UNITED STATES PATENT AND TRADEMARK OFFICE

APPLICATION NO.	FILING DATE	FIRST NAMED INVENTOR	ATTORNEY DOCKET NO.	CONFIRMATION NO.
10/516,890	12/03/2004	Etienne Degand	4004-064-30 NATL	1708
30448	7590	04/10/2006		
AKERMAN SENTERFITT P.O. BOX 3188 WEST PALM BEACH, FL 33402-3188			EXAMINER JEFFERY, JOHN A	
			ART UNIT	PAPER NUMBER

Office Action Summary

DETAILED ACTION

Passive non-heatable
Coated Zones
are shaded (▨▨▨)

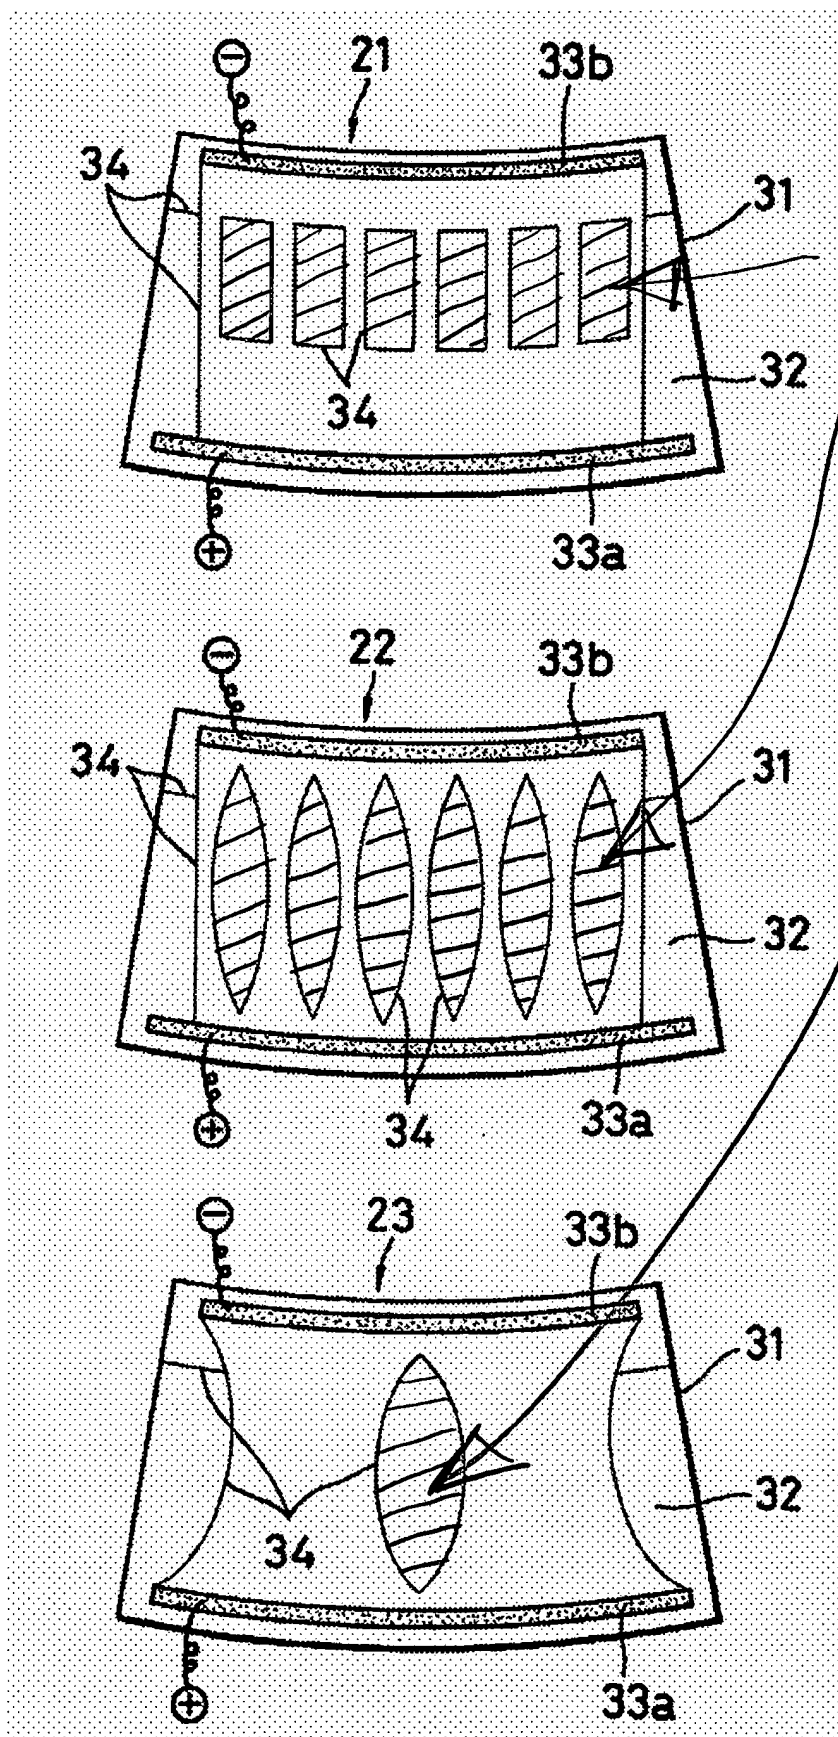
The claims differ from Thomson et al. (US 2,878,357) in calling for the zones to comprise (1) a non-heatable passive coated zone, and (2) an active coated zone that is electrically heated. GB2186769 discloses an electrically heatable glazing panel with a transparent electrically conductive coating layer comprising heatable active coated zones adjacent to passive non-heatable coated zones. See Figs. 2-5, 9, and 15. See also P. 1, lines 70-99. The passive non-heatable coated zones are those coated areas within the periphery of non-conductive slits 34. See the annotated figures from GB2186769 below for clarity. The arrangement shown in Figs. 2 and 5 of GB2186769 inherently forms adjacent heatable and non-heatable "strips."

Such an arrangement limits the current flow path along the heater layer to specific areas, thus varying the current density and altering the heating effect along the transparency as desired. By providing both active and passive coated zones, localized heating variations along the transparency can be achieved with a single electric heater coating by merely slitting the coating. In view of GB2186789, it would have been obvious to one of ordinary skill in the art at the time of the invention to provide active and passive heated and non-heated regions in the previously described apparatus to vary heating along the transparency, yet achieve such heating variation with a single electric heater coating by merely slitting the coating.

Regarding claim 10, the leftmost and rightmost non-heatable coated zones in Fig. 5 of GB2186769 fully read on the claimed "first glazing portion" and "second glazing portion" respectively.

Regarding claim 12, Fig. 2 of GB2186769 shows at least 50% of the coating's surface area comprising active coated zones.
